REGIONAL REVIEW FINDING

ARC REVIEW CODE: R410211

Submitting Local Government: City of Buford
Name of Proposal: Buford Distribution Center

Preliminary Report:	October 21, 2004	DEVELOPMENT OF REGIONAL IMPACT REVIEW REPORT	Project:	Buford Distribution Center #637
Final Report Due:	November 20, 2004		Comments Due By:	November 4, 2004

MASTER
SITE PLAN

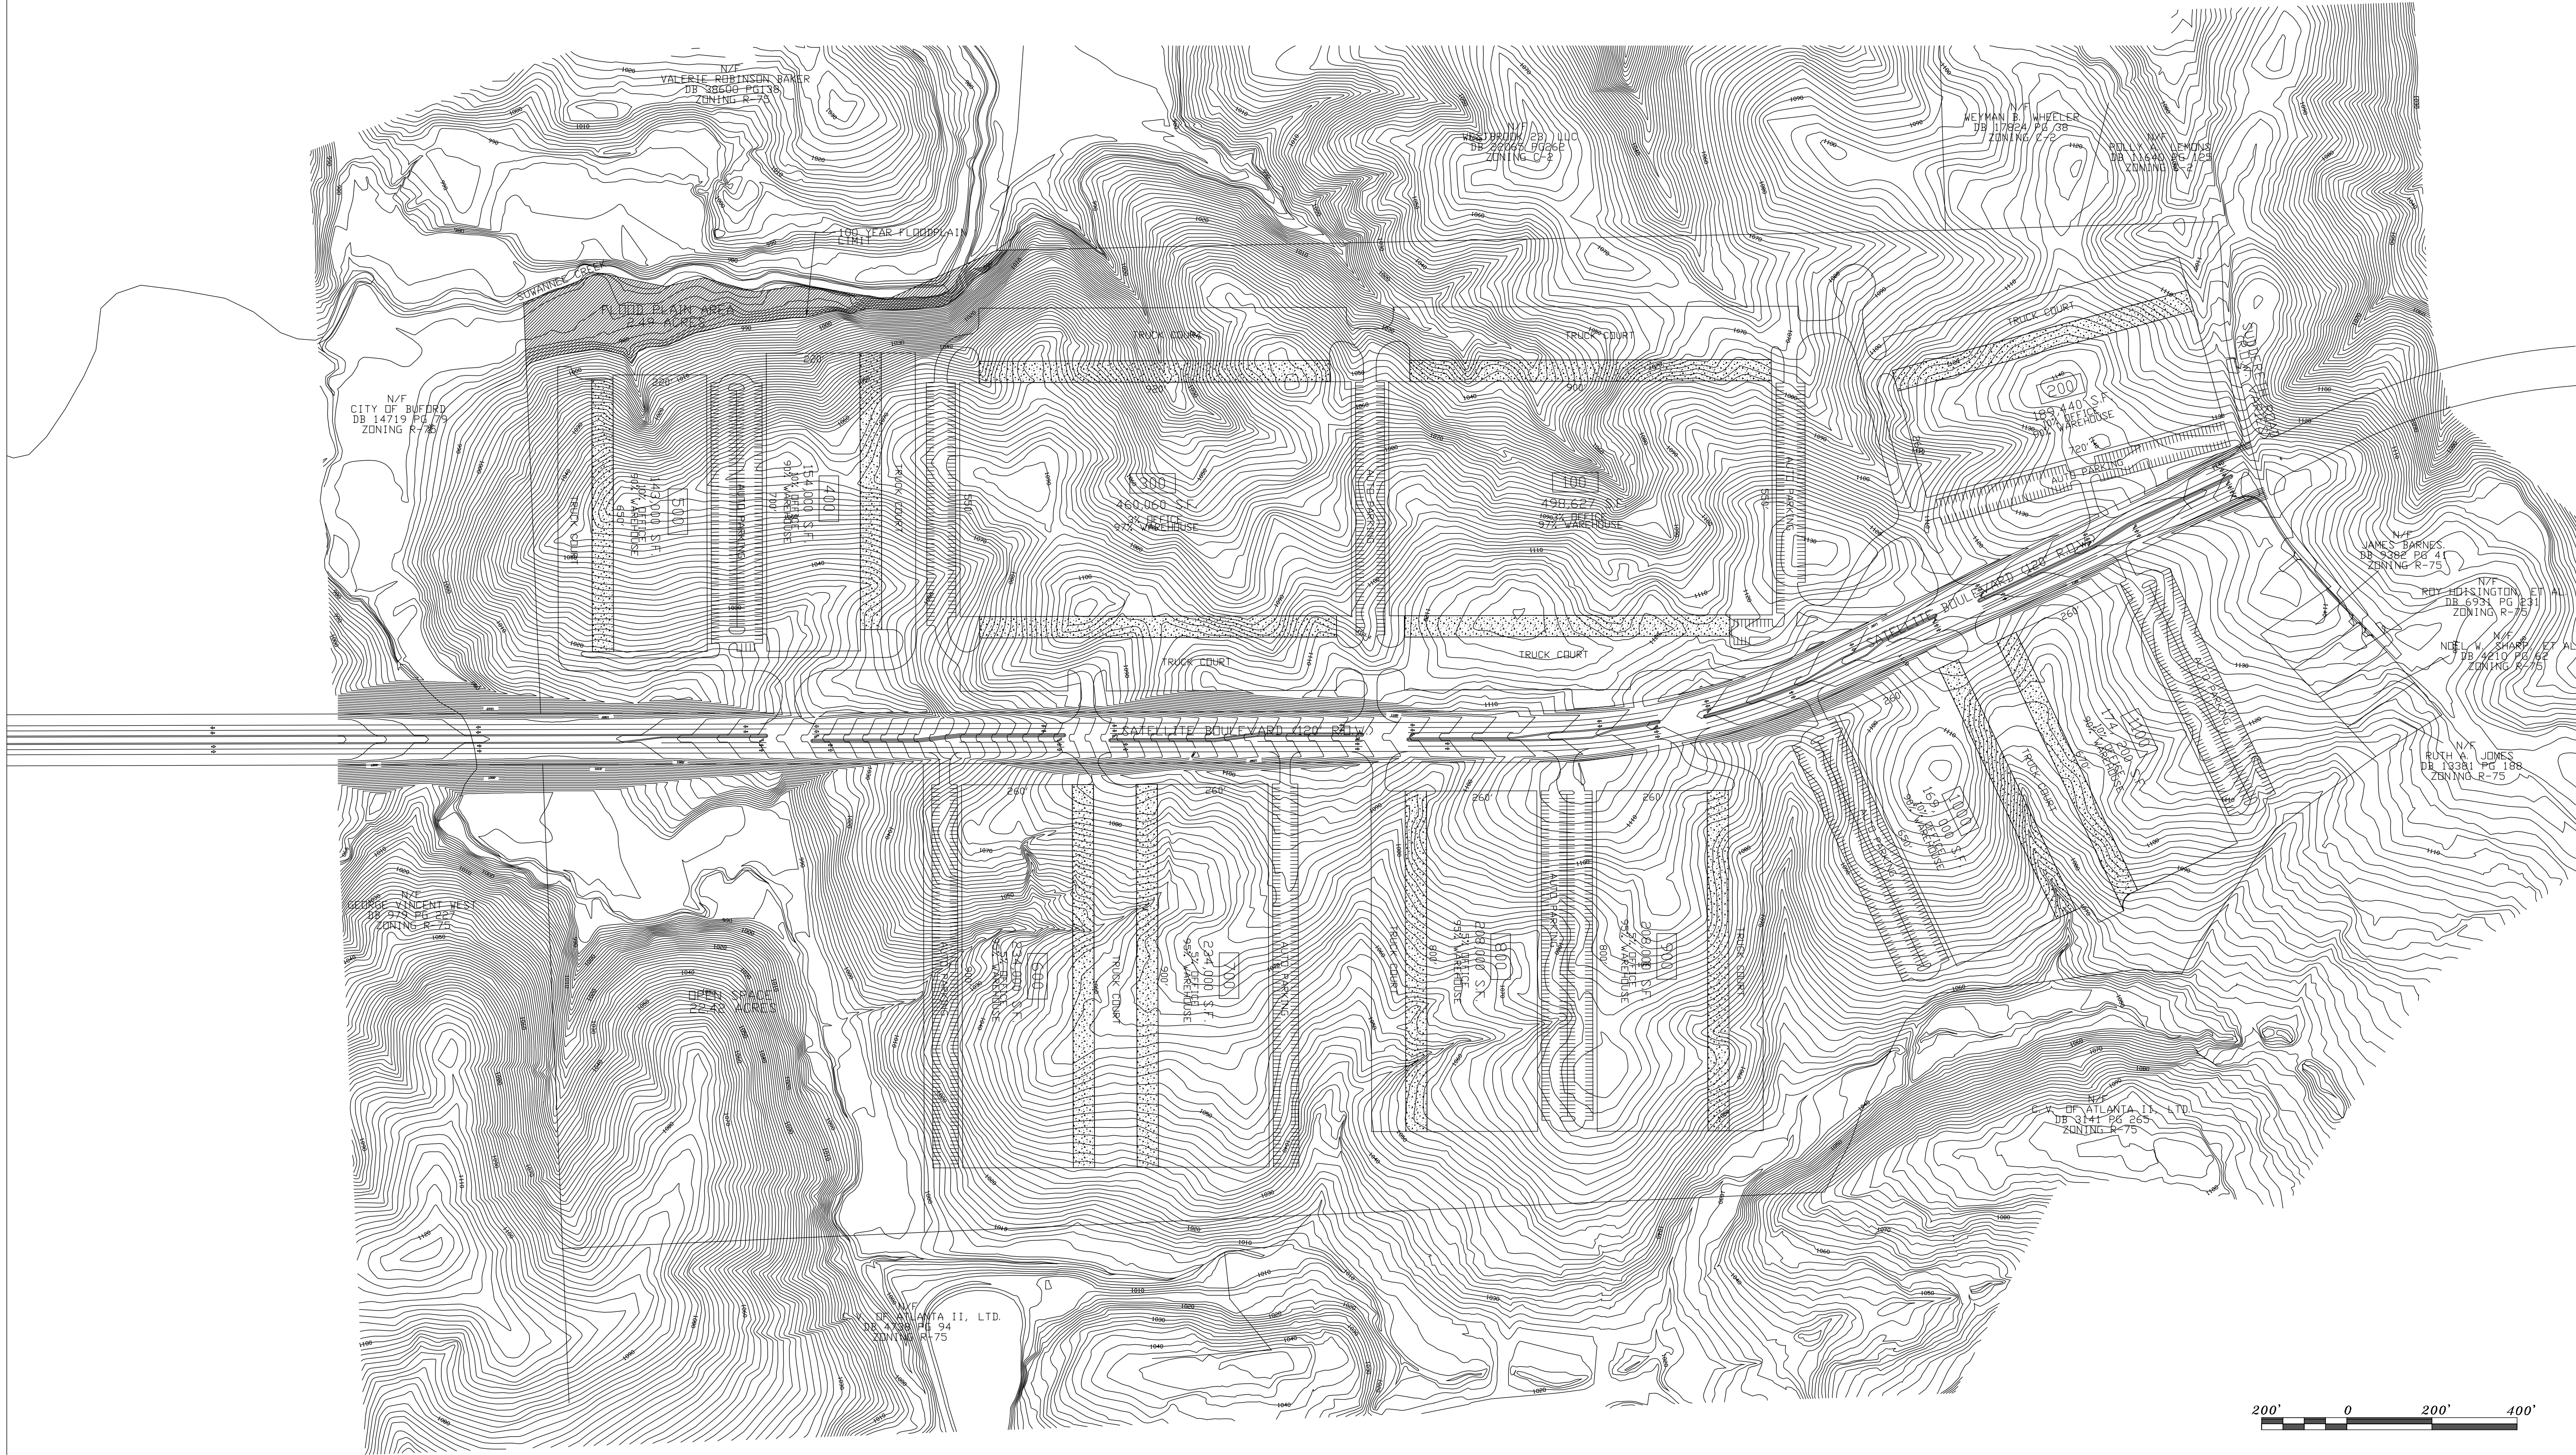
Buildings 100 and 300 should be reoriented as the same as Buildings 400 and 500, if possible. The truck courts should then be realigned to run alongside the buildings. If the buildings cannot be reoriented, then adequate landscaping along Satellite Blvd is encouraged to minimize the views from the road to the truck courts.

Grading of the site should be kept to a minimum where possible. In refining the site plan, it is recommended that significant consideration be given to grading and potential runoff, and kept to a minimum where possible. Finally, it is recommended that consideration be given to the type of materials used for construction of the parking lots and buildings to help reduce the urban heat island effect. The developer should consider pervious pavement and reflective roofing where possible. It is recommended that resources and information from the U.S Green Building Council, American Planning Association, U.S. EPA, Cool Communities, and Project ATLANTA (Atlanta Land Use Analysis: Temperature and Air Quality) study be reviewed. The Best Environmental Practices listed below should be reviewed and applied to the development where possible.

Buildings 100 and 300 should be reoriented as the same as Buildings 400 and 500, if possible. The truck courts should then be realigned to run alongside the buildings. If the buildings cannot be reoriented, then adequate landscaping along Satellite Blvd is encouraged to minimize the views from the road to the truck courts.

Grading of the site should be kept to a minimum where possible. In refining the site plan, it is recommended that significant consideration be given to grading and potential runoff, and kept to a minimum where possible. Finally, it is recommended that consideration be given to the type of materials used for construction of the parking lots and buildings to help reduce the urban heat island effect. The developer should consider pervious pavement and reflective roofing where possible. It is recommended that resources and information from the U.S Green Building Council, American Planning Association, U.S. EPA, Cool Communities, and Project ATLANTA (Atlanta Land Use Analysis: Temperature and Air Quality) study be reviewed. The Best Environmental Practices listed below should be reviewed and applied to the development where possible.
